**ADDENDUM # 10**

**WEGO Transit and Fleet Operations Center Expansion**

**Request for Proposal No: RFP-22-2024-AD**  
**Issue Date of Addendum: January 16, 2025**  
**Proposal Submission Deadline: January 23, 2025 at 2:00 p.m. ET**

**ADDENDUM No.2**

1 Roof Plan  
A2-200  
scale: 1: 200

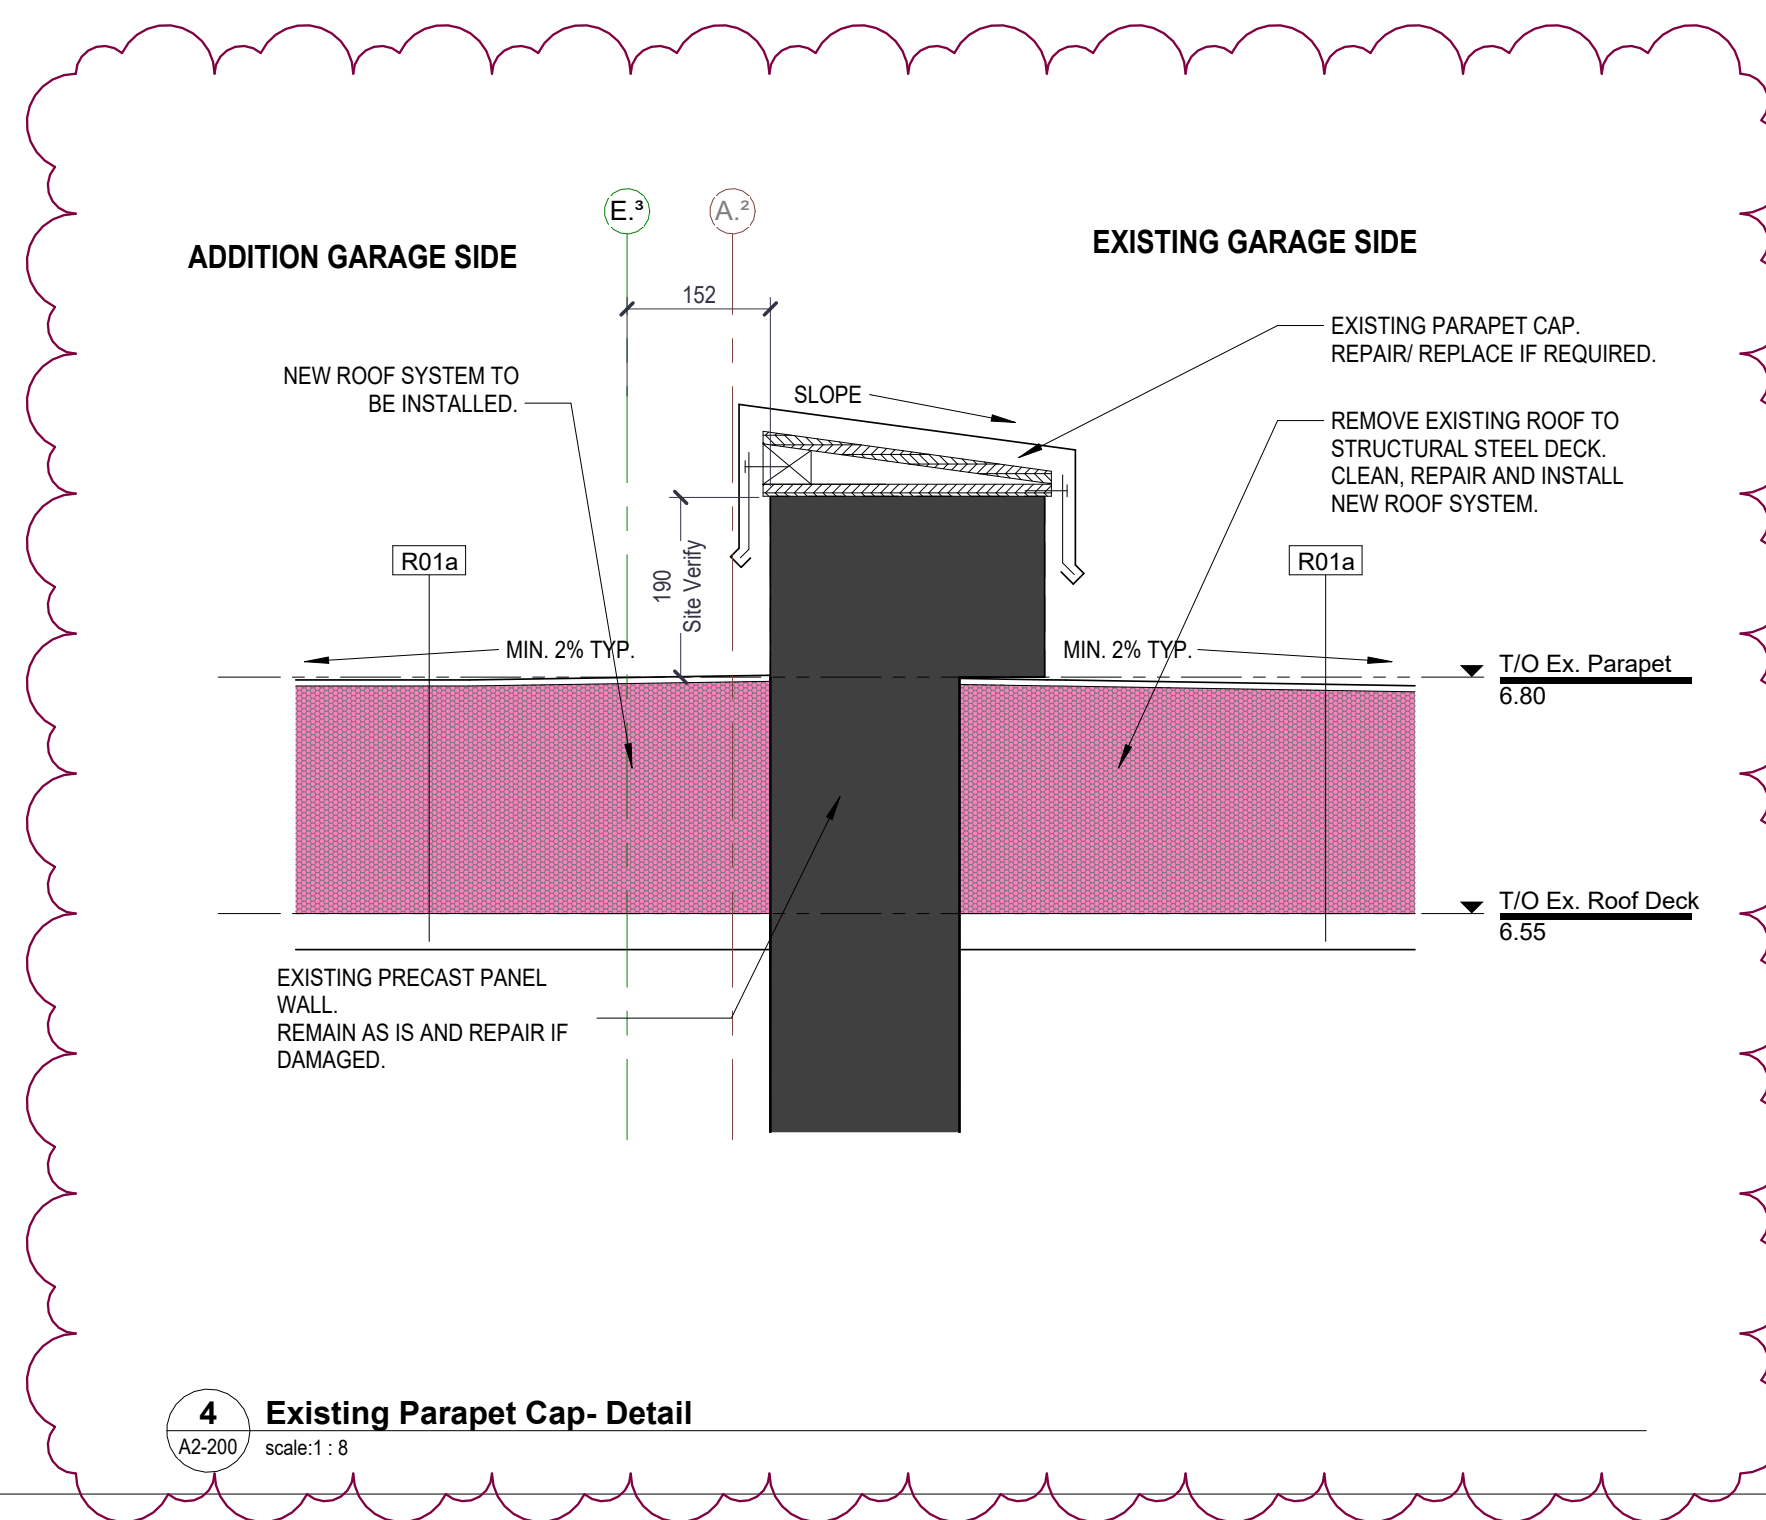
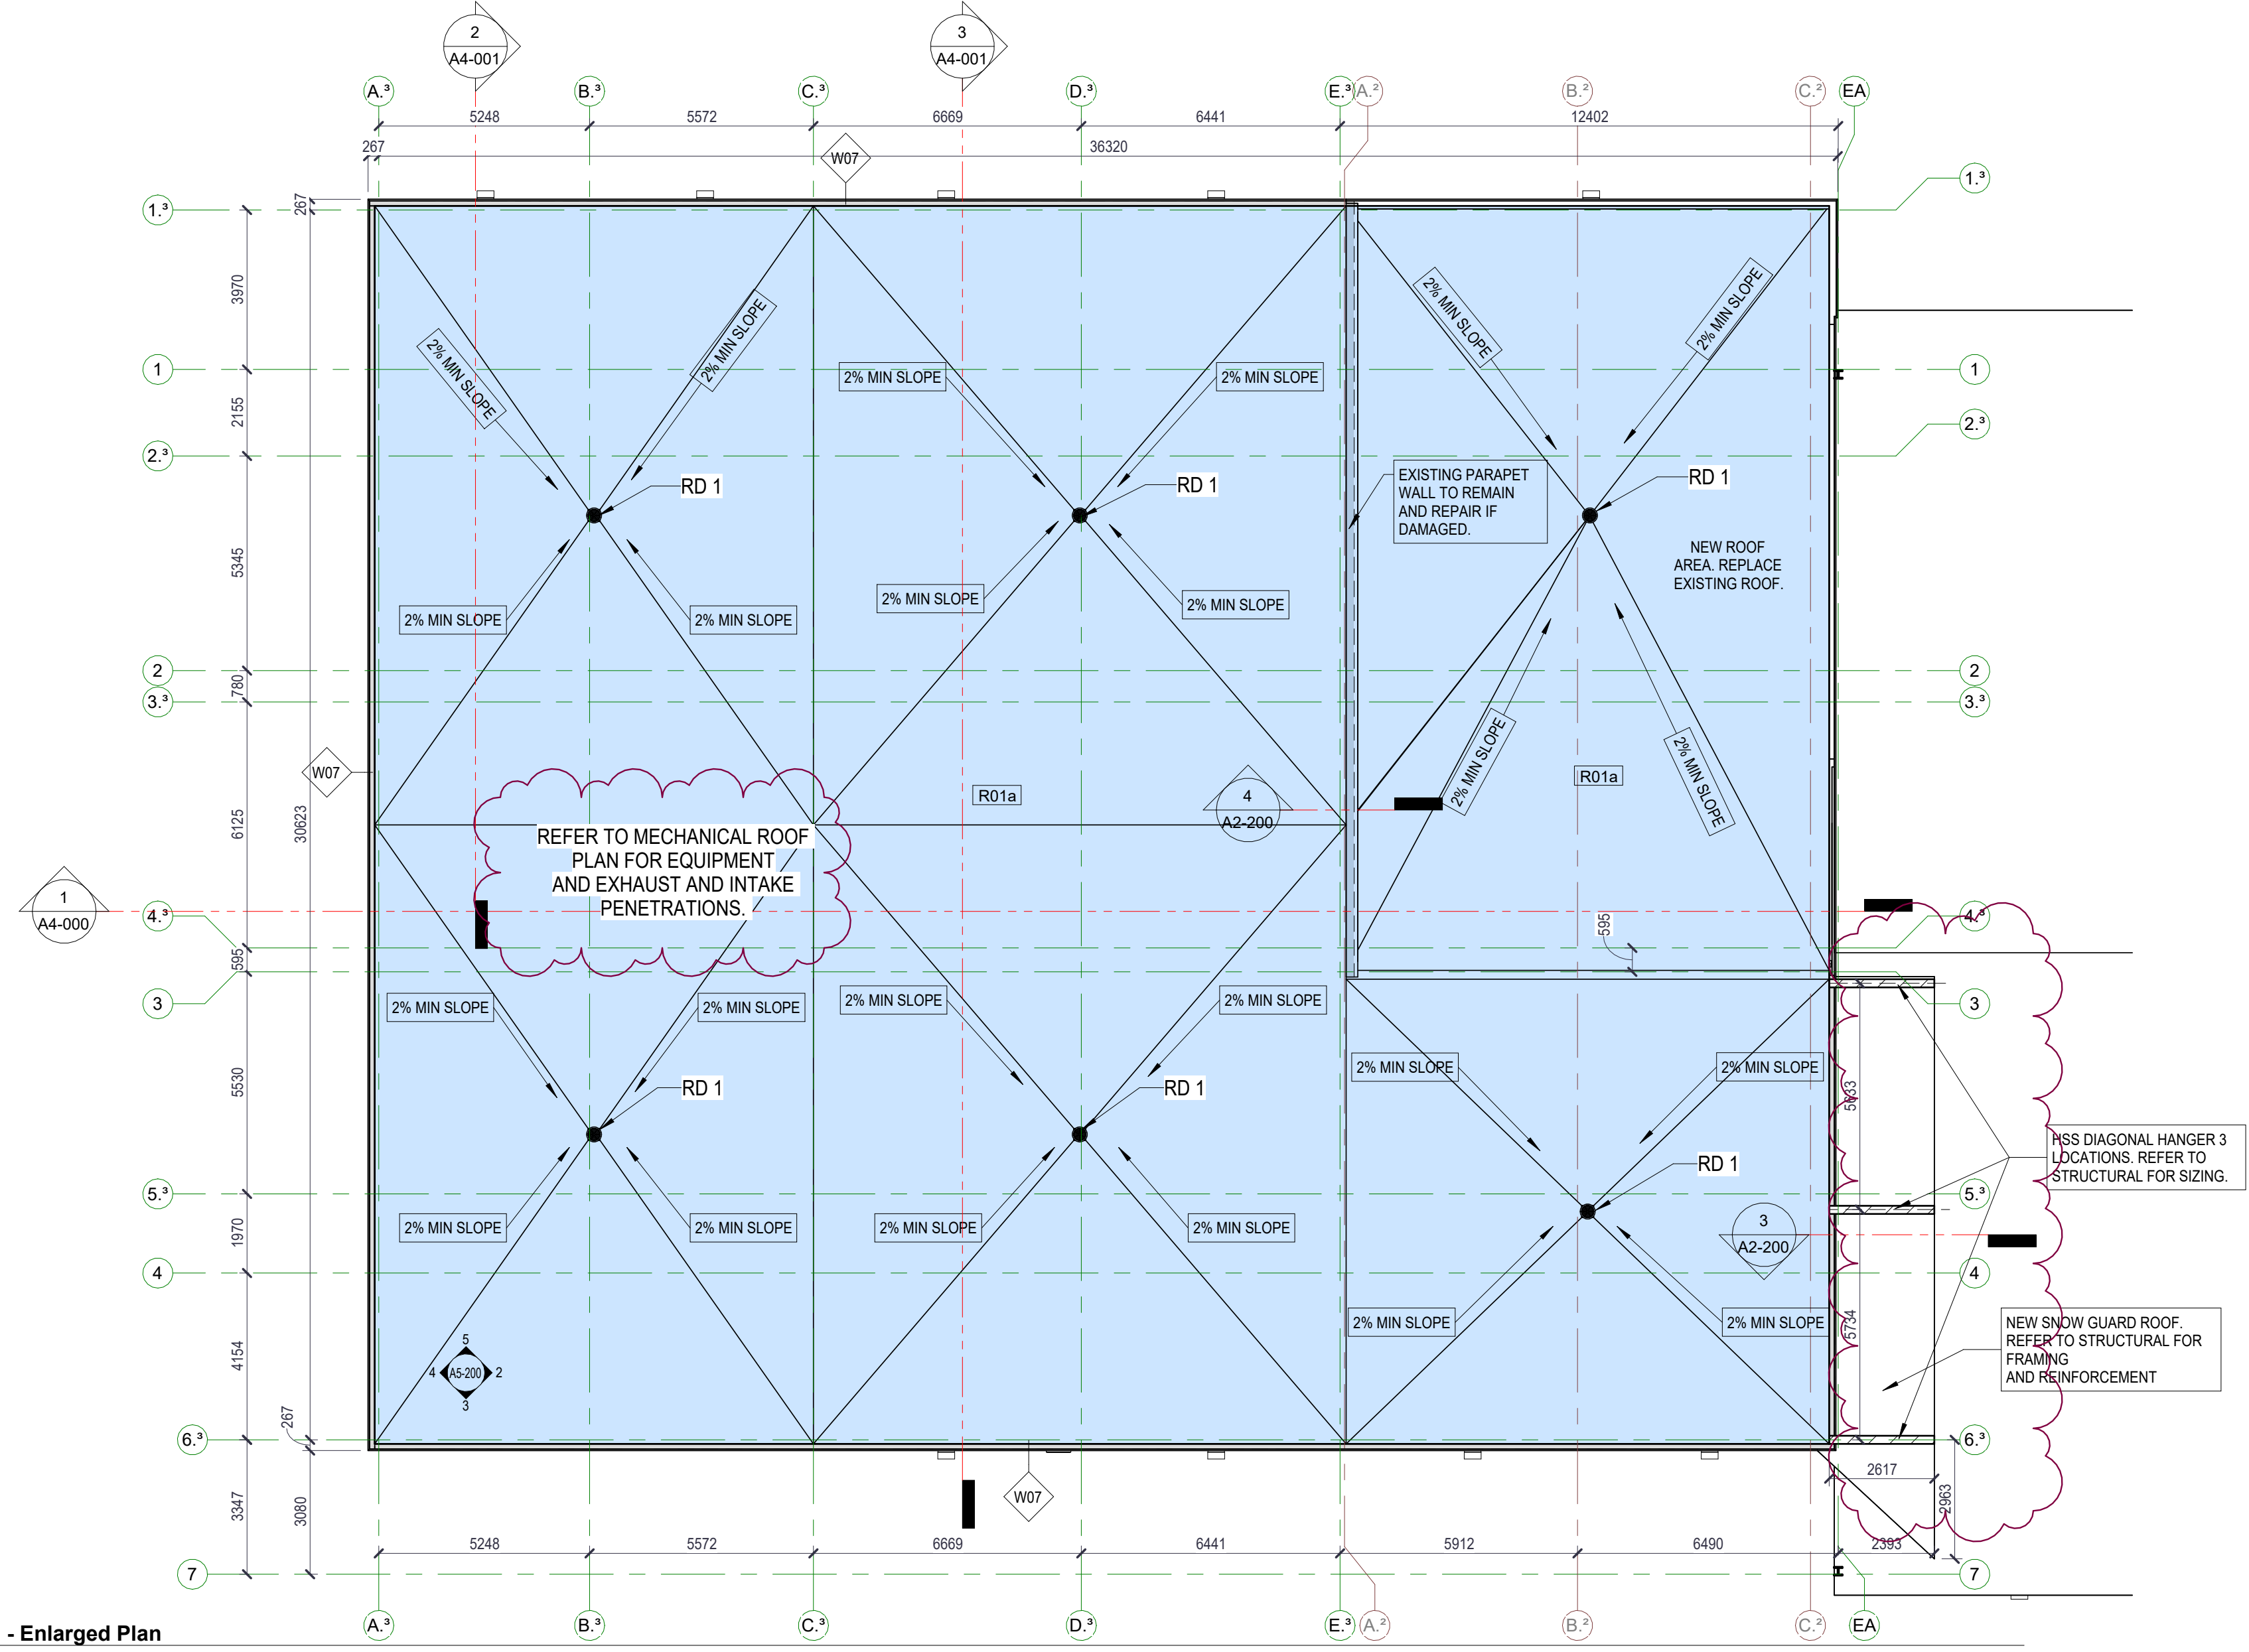
- 2.1 [Remove intumescent fireproofing detail.]
- 3.0 **Clarification: DRAWINGS – [A2-200] – [Roof Plans]**
  - 3.1 [A note was added to refer to mechanical for roof openings.]

- 3.2 [Parapet detail added at existing building for reference.]
- 4.0 **Clarification: DRAWINGS – [A5-300] – [Enlarged Section Details]**
  - 4.1 [Updated Window details to include C-channel Furring wall to match plans.]
